HQDFM Design for Manufacture(DFM) Report

File name: 2024-07-25

Time: 2024-07-25 Layer count:2 PCB Thickness: 1.60 Quantity: 5 mm

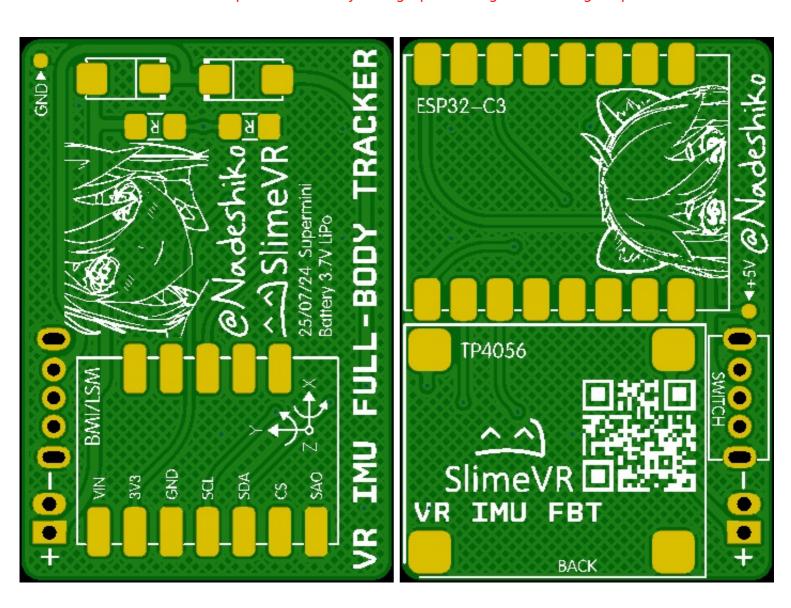
The file size is small, which can affect the surface mount assembly process. It is recommended to have a size larger than 7*7cm. You can optimize the size by adding a process edge or increasing the panelization.
